Invitation to Bid COMMUNITY CENTER BASEBALL FACILITY

The Confederated Tribes of the Chehalis Reservation Community Center Baseball Batting Facility Project

CHEHALIS TRIBE
BASEBALL BATting CAGES

PERMIT SET
PLANS AND ELEVATIONS

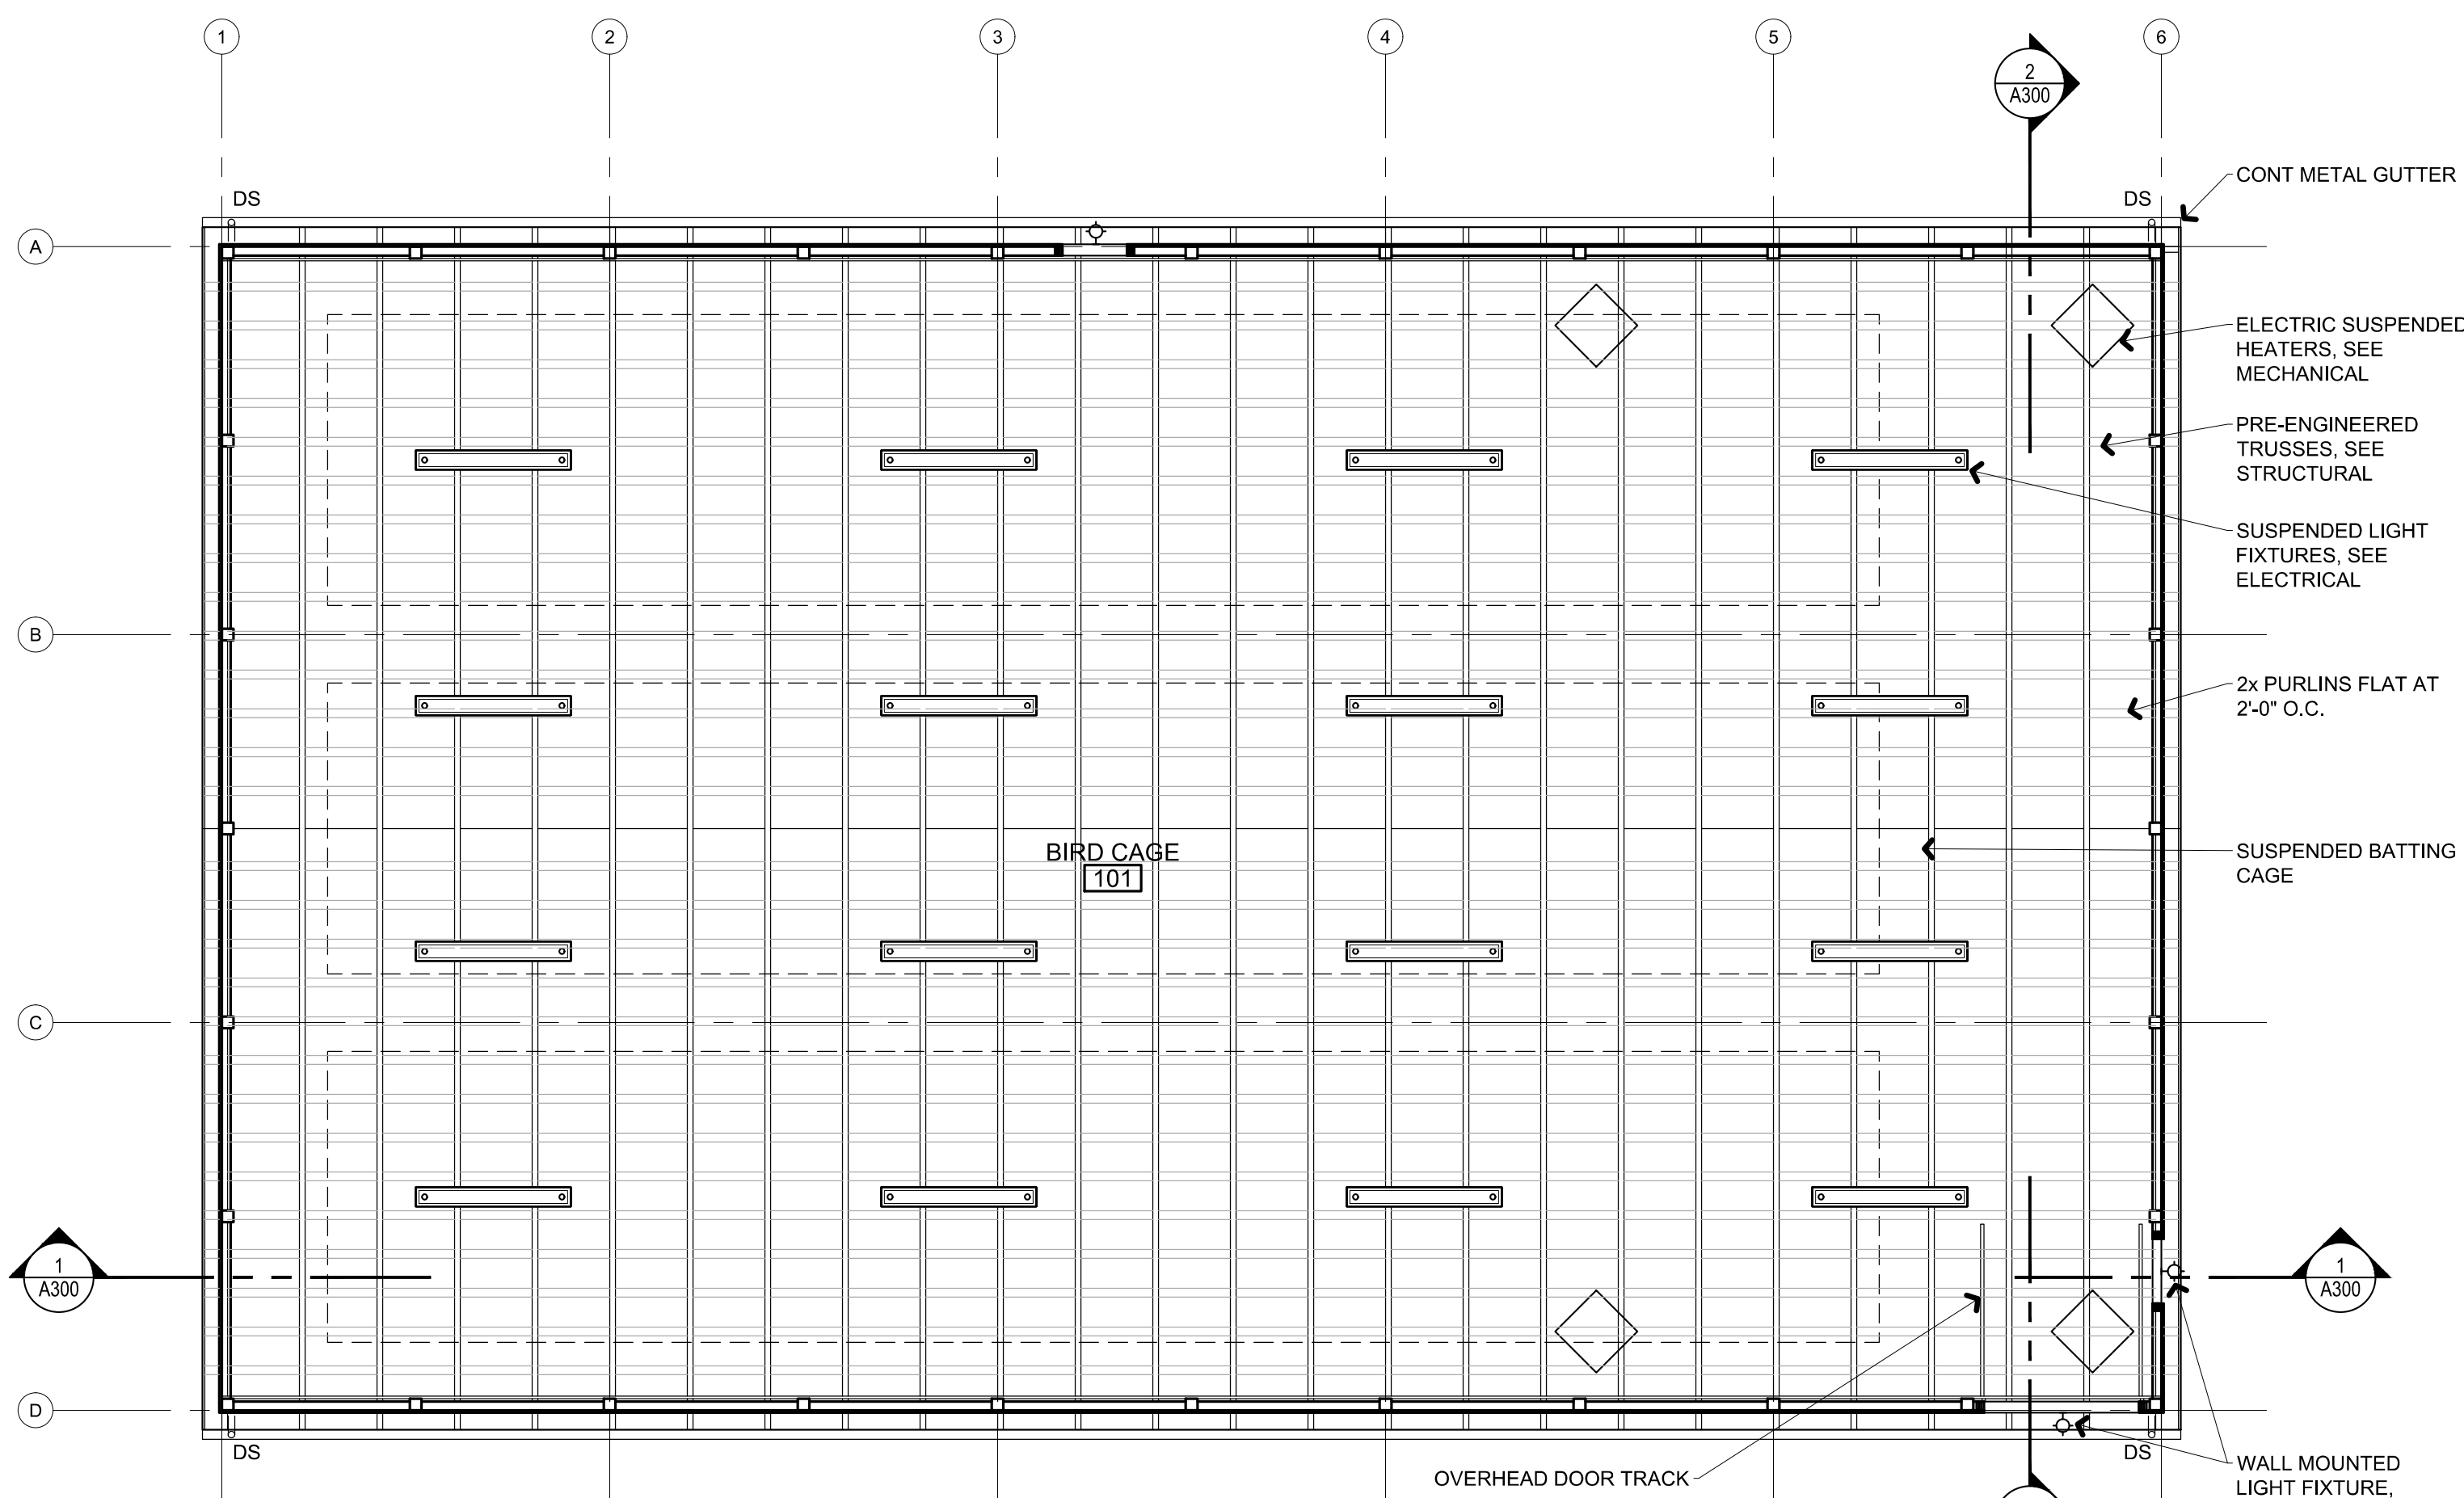
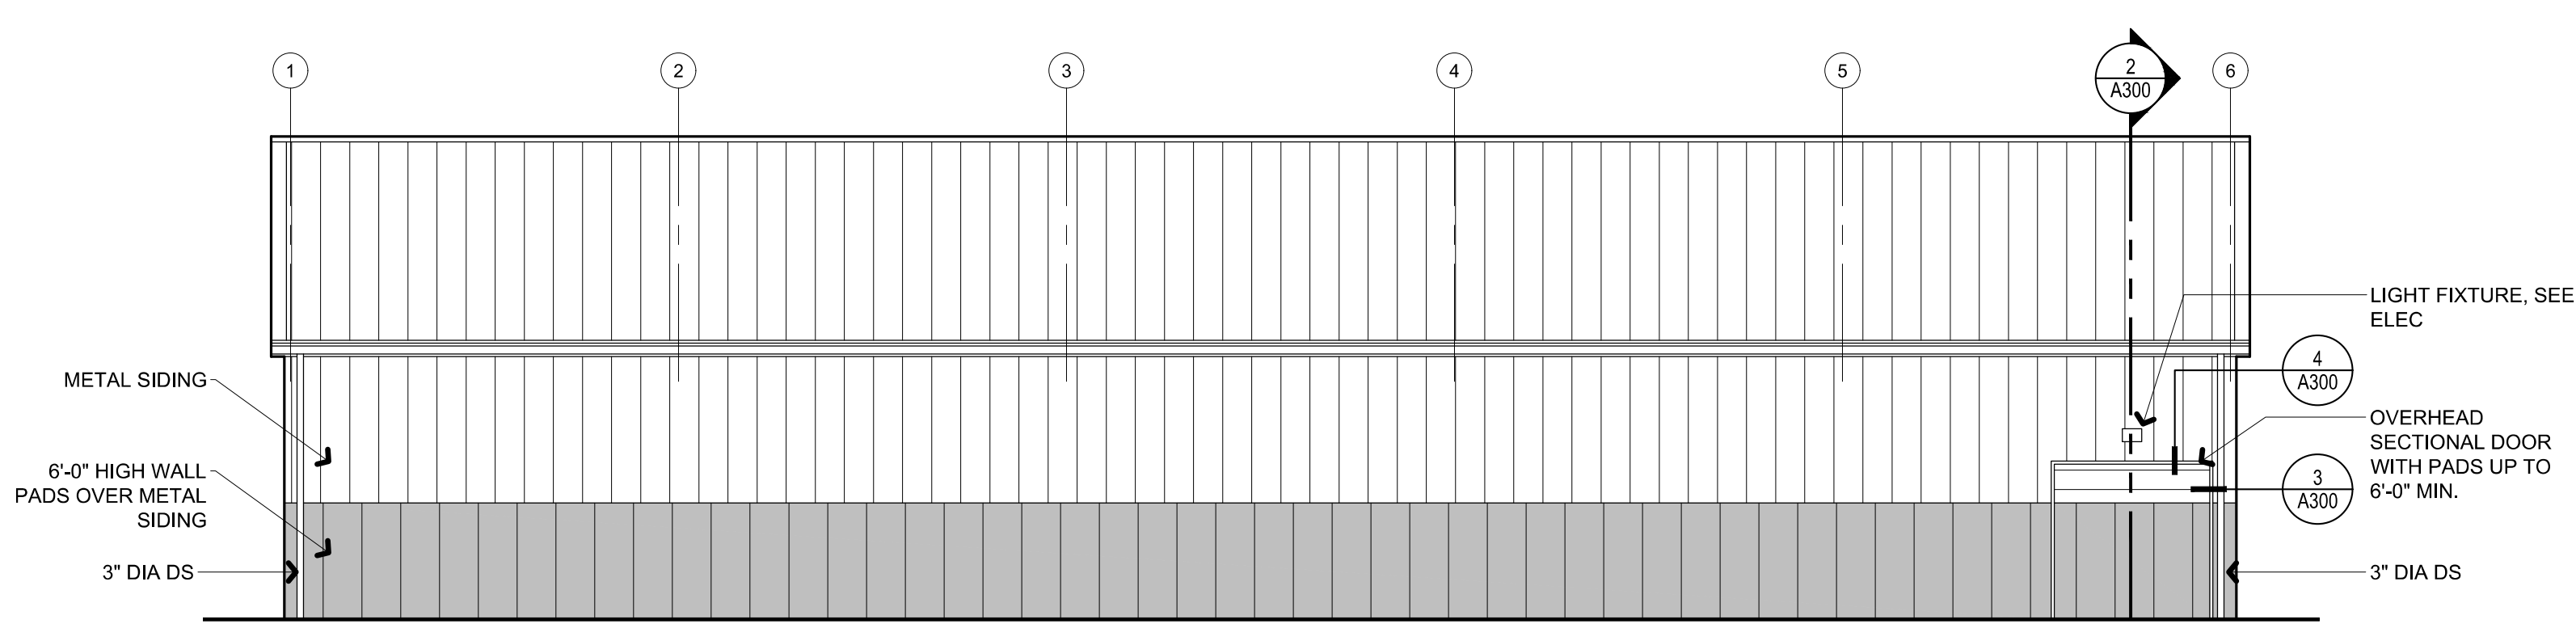
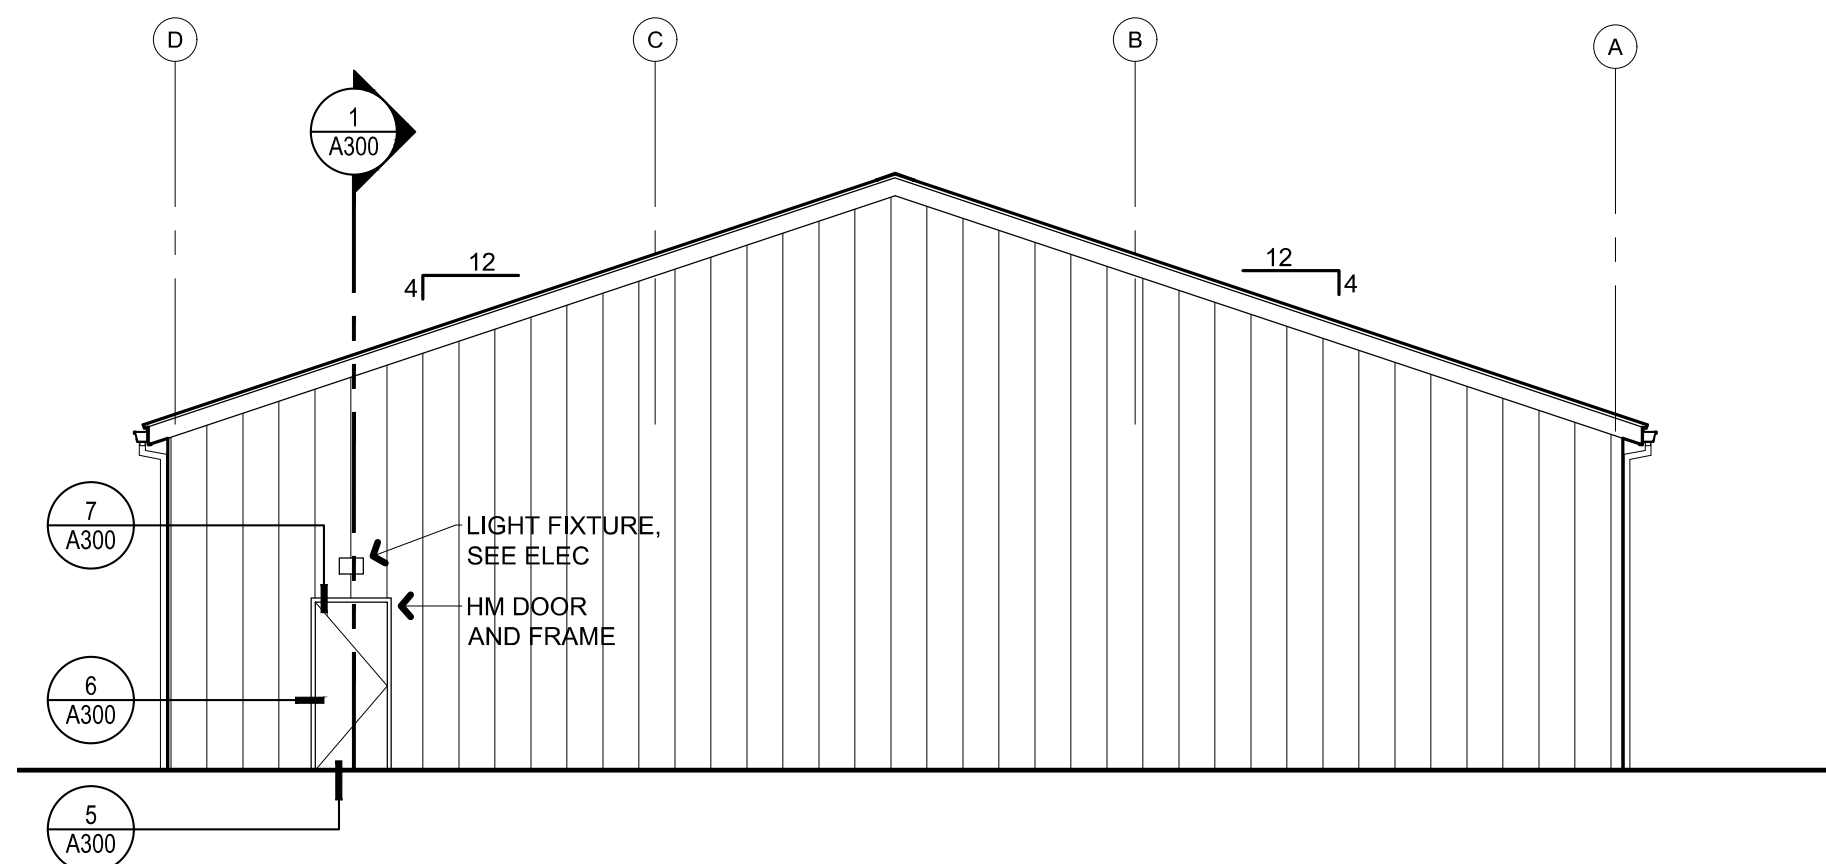
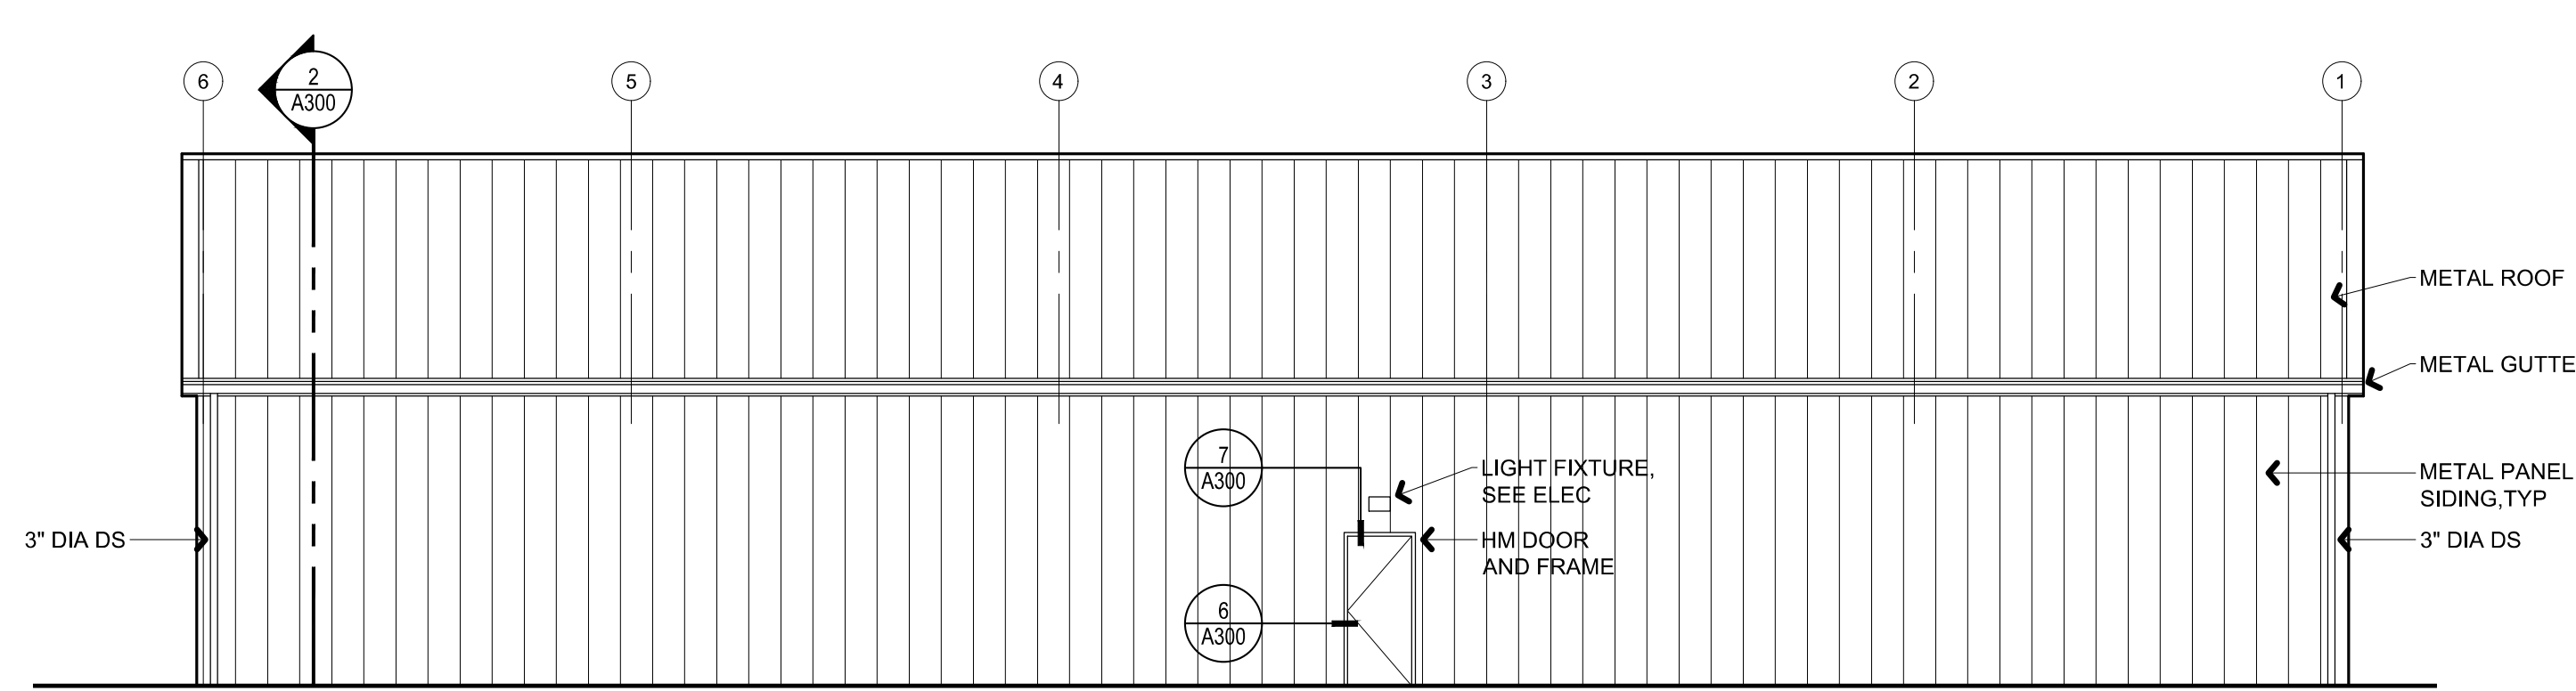
1. Miscellaneous
 - a. This building is not equipped with a fire sprinkler system.
2. Revise A101
 - a. The overall building dimension is 120' long by 60' wide.

- b. Detail 5 – Delete the pads over metal siding.
 - c. Detail 1 – See civil site plan for exterior door locations. All doors shall be insulated metal exterior rated. There are 2 – 8'x8' Exterior Overhead Doors and 2 – 3'-0" x 7'-0" HM Exterior Door and HM Frames.

- d. Detail 1 – Delete chain link fence and gate inside the building.
 - e. Detail 1 – Batting netting are not a sole source item.
 - f. Metal shall be 29 GA Colored Steel. Owner will pick color from contractor provided color chart.

- g. Reflected Ceiling Plan Lighting: The lights shall be Lithonia Lighting CPHB 30LM MVOLT 50K Compact PRO LED Bay Light, High Bay, 30000 Lumens, 5000K Light (20 ea)
